SAFETY RECALL CODE 0813 - SIDESTAND SWITCH

Buell Motorcycle Company has learned that certain 1996 through 1999 Buell motorcycles were built with a sidestand switch that could become inoperative. This condition could cause the engine to stall or quit when riding which could result in an accident. Accordingly, Buell Motorcycle Company is conducting a voluntary recall campaign to formally recall all potentially affected motorcycles.

This campaign involves all 1996 through 1999 S1 Lightning, S1 White Lightning, X1 Lightning, M2 Cyclone, S3 Thunderbolt and S3T Thunderbolt model Buell motorcycles manufactured between January 20, 1995 and April 21, 1999.

Figure 3. New Switch Assembly

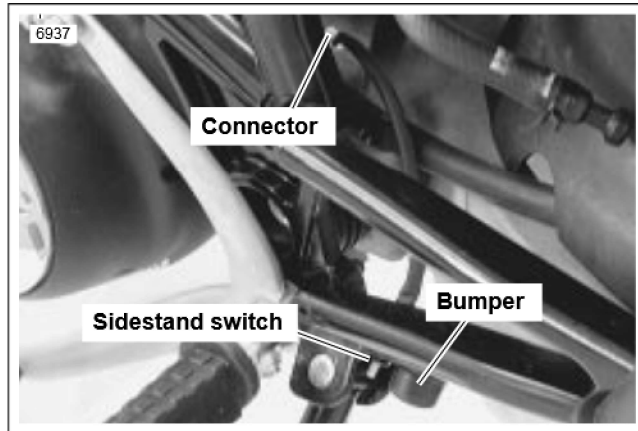
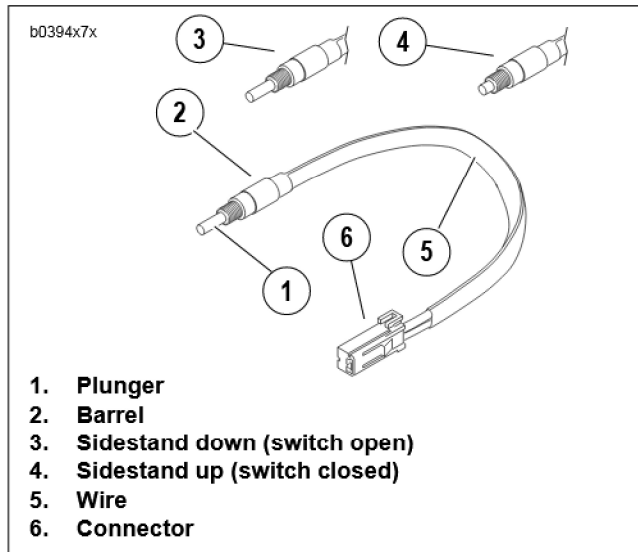
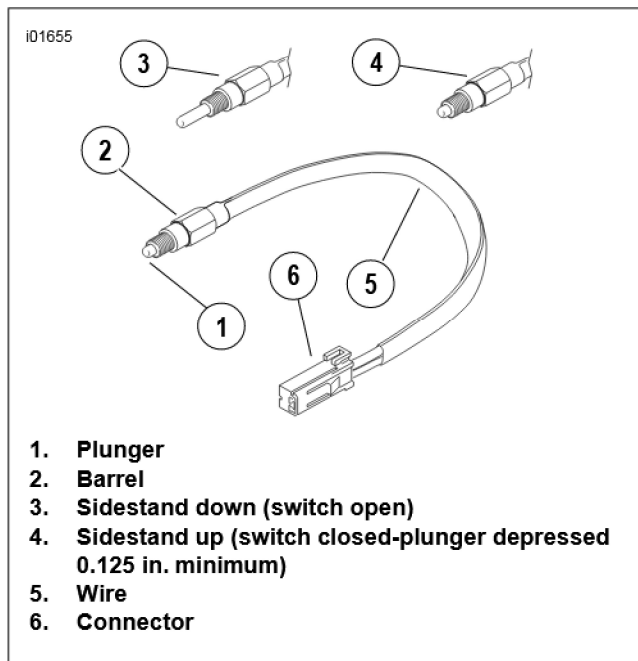
See Figures 1, 2 and 3. The current sidestand switch can be differentiated from the replacement one by noting the differences in the plunger. The current plunger is made of white plastic and has a flat tip. The plunger of the replacement switch is made of metal and has a round tip.

1. Thoroughly clean the switch frame mounting area and threads.
2. Install switch into frame so that plunger is facing down. Torque to 25-35 in. lbs. (2.8-4.0 Nm).

Figure 4. Dimension "A" Measurement

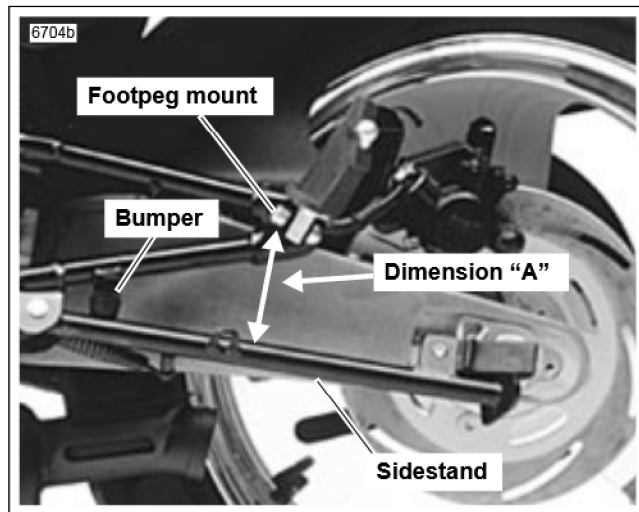
- See Figures 5 and 6. Dimension "B" is determined by measuring the distance perpendicular to the left outside surface of the swingarm to the sidestand dragger mount.
- See Figure 4. Dimension "A" is determined by measuring the distance perpendicular to the top side of the sidestand to the lower edge of the passenger footpeg front mount tab.

1. Remove and discard original sidestand bumper and spacer washers.
2. See Figures 4 and 5. Establish correct sidestand retraction angle by using either the new cylindrical bumper or the new conical bumper in conjunction with up to three spacer washers. The sidestand retraction angle is defined by Dimension "B". Dimension "B" must be within 0.500-0.625 in. (13-16 mm). Keeping Dimension "B" within specifications listed, measure Dimension "A". Dimension "A" must not exceed 3.125 in. (79 mm).
3. Using the bumper and washer combination determined in Step 2, place a small amount of LOCTITE THREAD-LOCKER 243 (blue) on the bumper threads and install it into the frame.
4. Hand tighten securely.

Figure 5. Dimension "B" Measurement

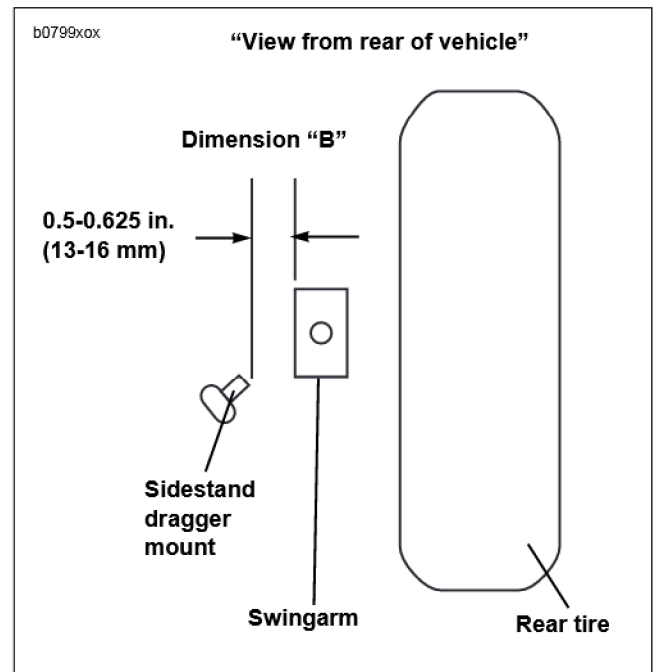
See Figures 3 and 5. The objective of this procedure is to obtain both a **minimum** sidestand switch plunger depression of 0.125 in. (3 mm) and a **minimum** sidestand/swingarm clearance (Dimension "B") of 0.5 in. (13 mm) when the sidestand is in the retracted position.
